NEDO-33075-A, Revision 6
DRF-0000-0044-7571
Class I
January 2008

**GENERAL ELECTRIC BOILING WATER REACTOR
DETECT AND SUPPRESS SOLUTION – CONFIRMATION DENSITY**

SUBJECT: FINAL SAFETY EVALUATION FOR GENERAL ELECTRIC NUCLEAR ENERGY (GENE) LICENSING TOPICAL REPORT (LTR) NEDC-33075P, REVISION 5, "GENERAL ELECTRIC BOILING WATER REACTOR DETECT AND SUPPRESS SOLUTION - CONFIRMATION DENSITY" (TAC NO. MC1737).

**Figure 7-1 Base Manual BSP Regions Generation Basis Relative to ICA Regions
(100% EPU = 120% OLTP)**

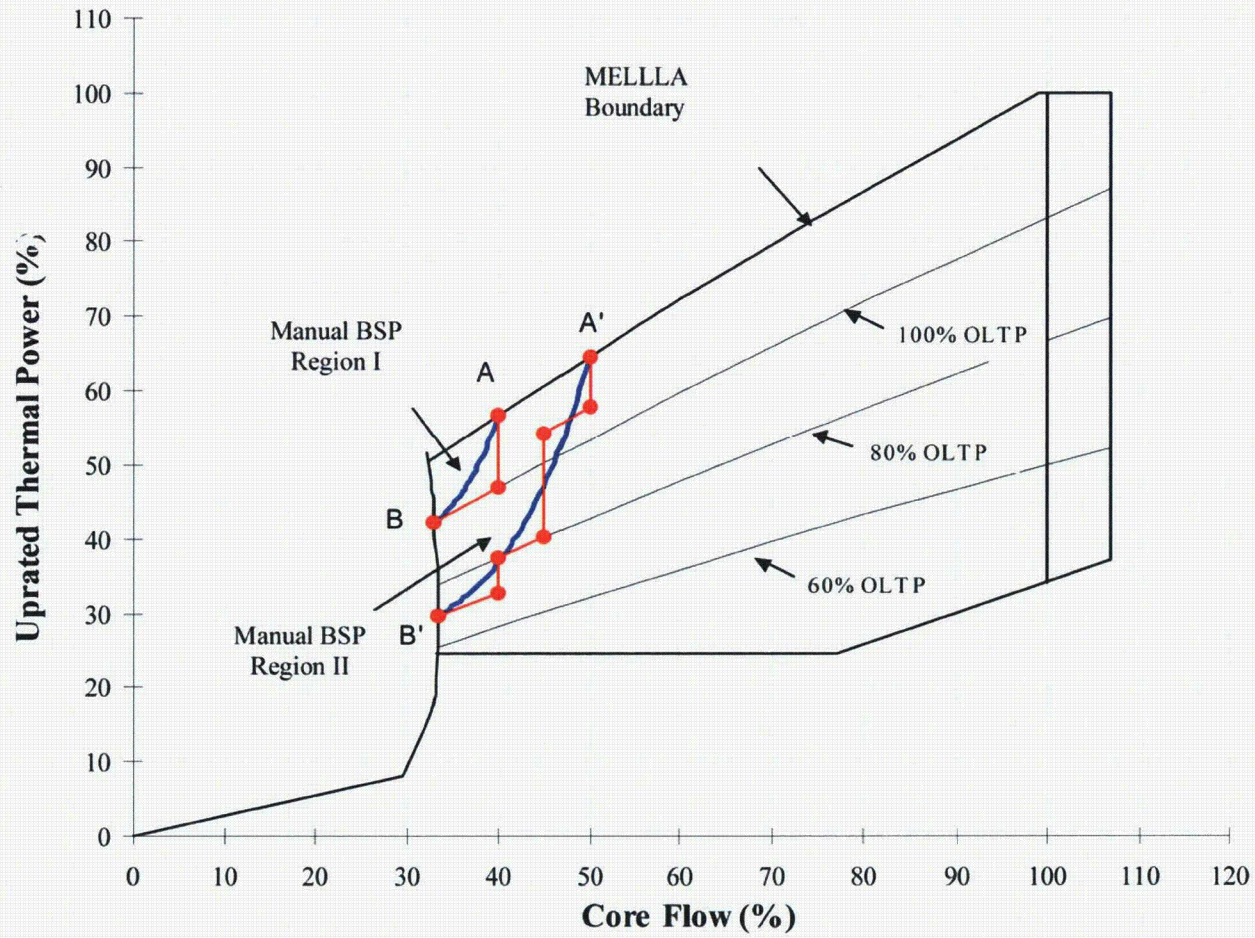
On page 7-5, a typo shows that A' should be A in Figure 7-1.

This is not a typo. The BSP methodology for Region II (Controlled Entry Region) is for the stability criterion associated with 0.8 core and channel decay ratios to be applied to point B' and the stability criterion associated with 0.6 core and channel decay ratios to be applied to point A'. Figure 7-1 correctly shows BSP Regions I and II and the associated points A, B, A', and B'. The 0.6 criterion is used for point A' rather than 0.8 to provide additional stability margin for operation at off-rated conditions.

Figure 7-3 Stability Criteria

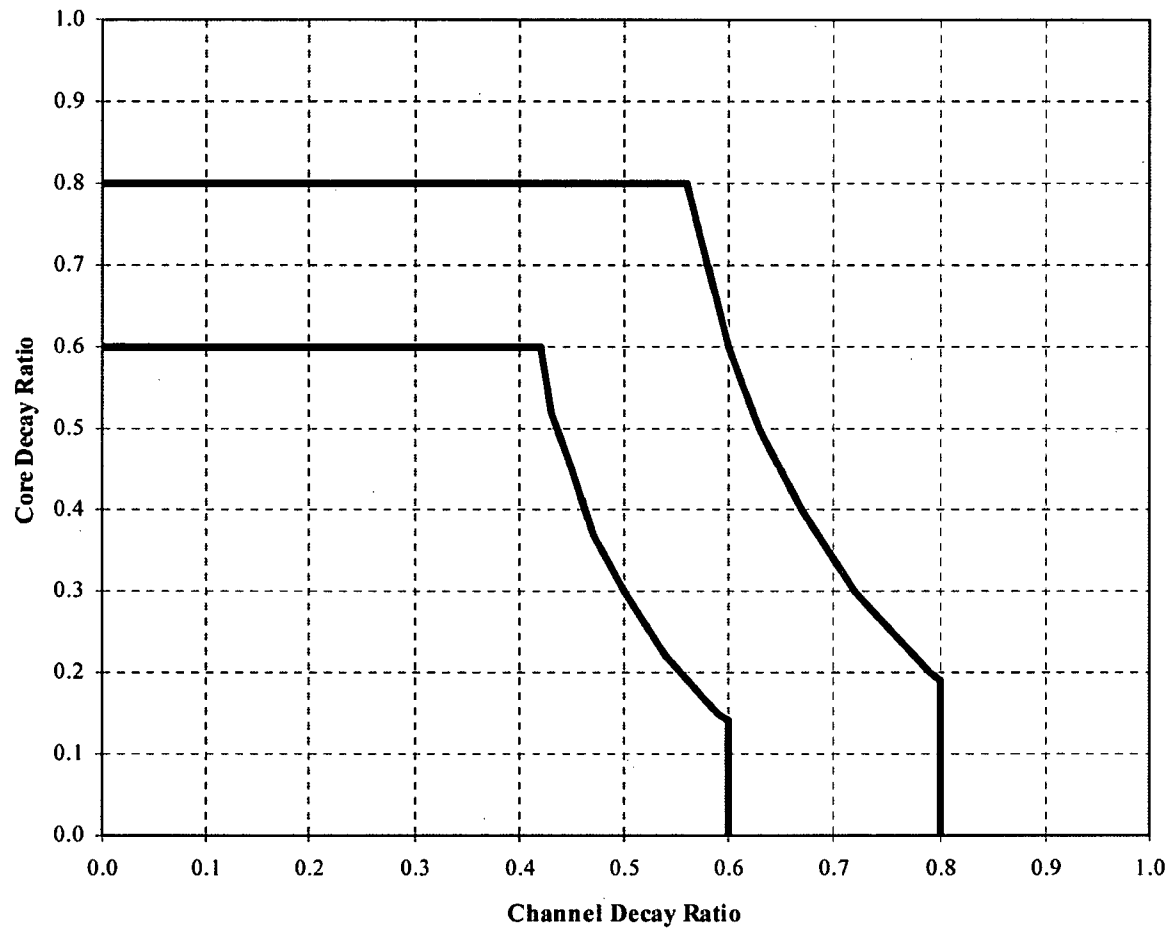
A simple extrapolation of the Region II “Controlled Entry” line of Figure 7-3 shows that this region would be very close to the maximum extended load line limit analysis plus (MELLLA+) upper boundary. The regions illustrated in Figure 7-3 are the base minimal regions; thus, the actual regions in MELLLA+ reactors cannot be smaller. What is the rationale for not calculating the stability of a new point (call it C’) at the MELLLA+ upper boundary line and confirming that the MELLLA+ allowed operating domain is not inside the controlled entry region?

Figure 3.

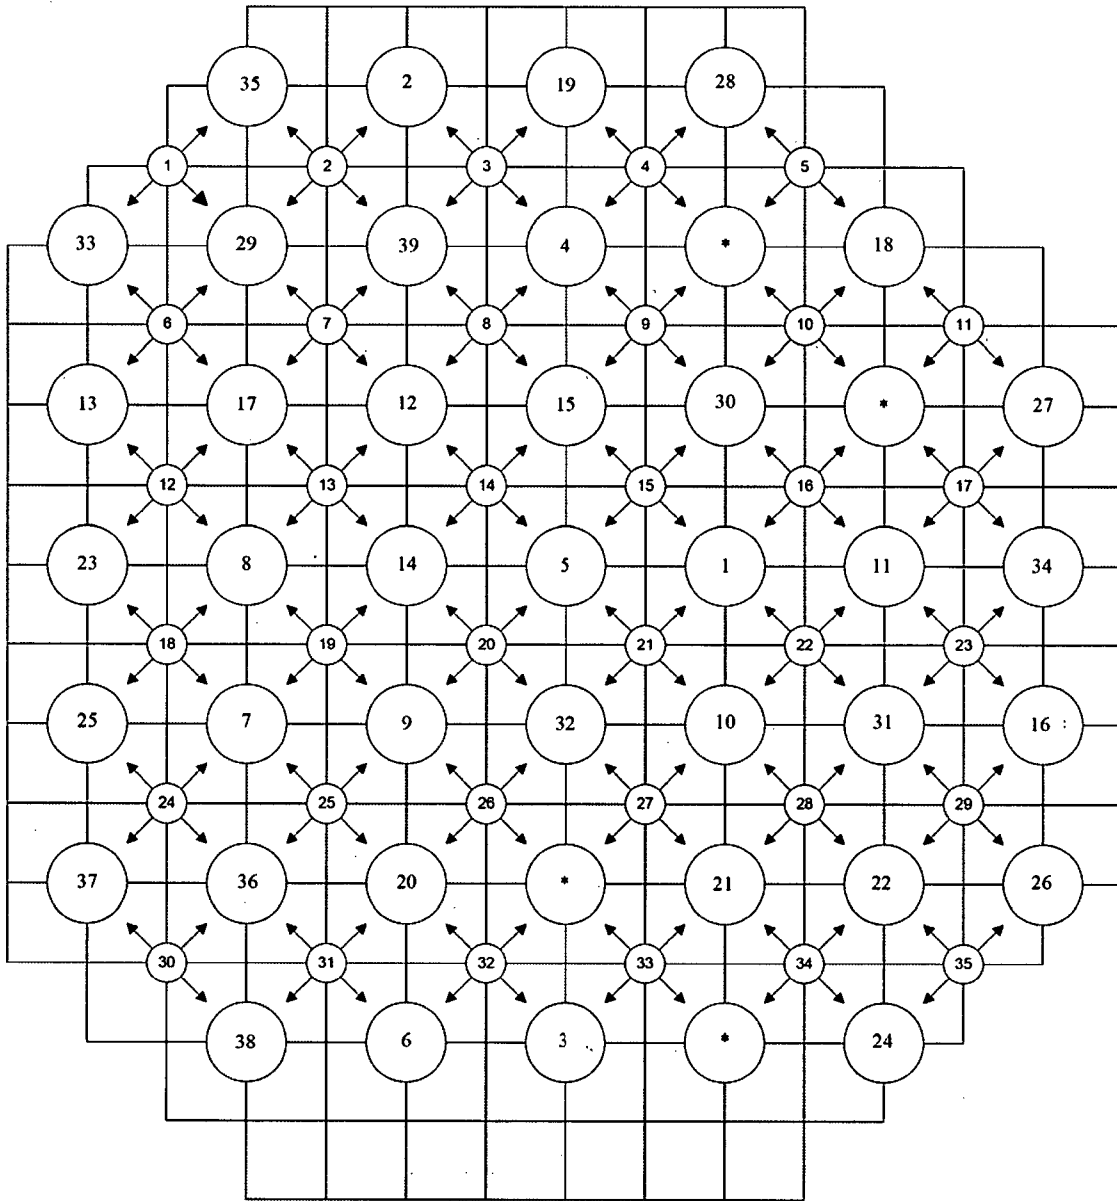
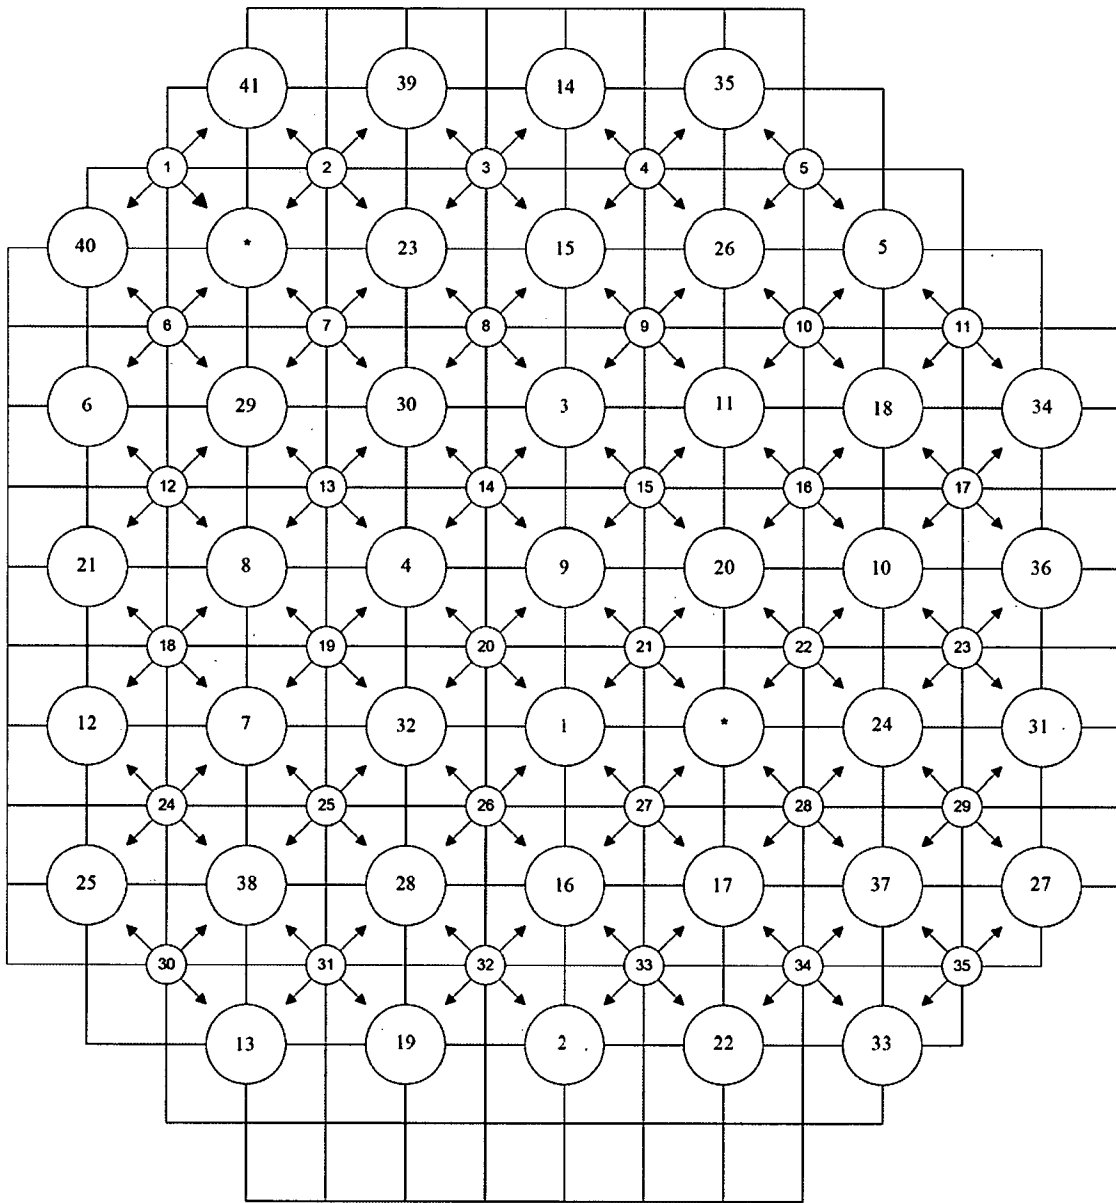
Figures 3 and 4 provided below show the location of the LPRM signals for the Columbia plant. The number in each cell provides the order in which each LPRM signal reaches the successive period confirmation count setpoint [[]] for the instability event corresponding to Figures 5-4 and 5-5 of the DSS-CD LTR. [[
